PCN – Product Change Notice

PCN #: 060724

Date: July 24, 2006

All V•I Chip BCMs and VTMs

New style of J-lead

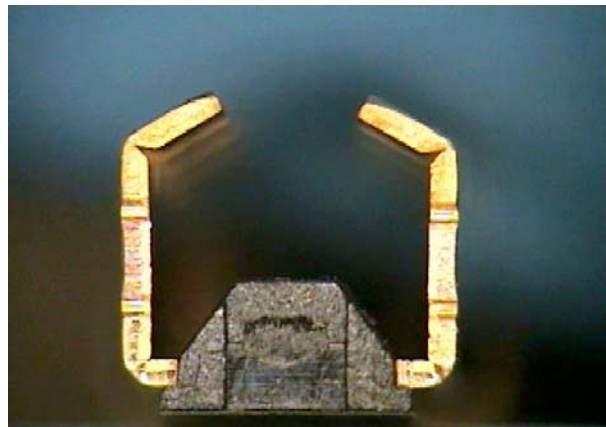
All V•I Chip BCMs and VTMs will use new, pre-formed J leads with improved co-planarity. Customers may notice a minor indentation and a minor difference in plating compared to the old version. There are no dimensional changes and all products conform to data sheet specifications. Vicor Quality testing has confirmed the product continues to meet the published specifications.

No changes to customer's printed circuit board layout or soldering processes are required as a result of this change.
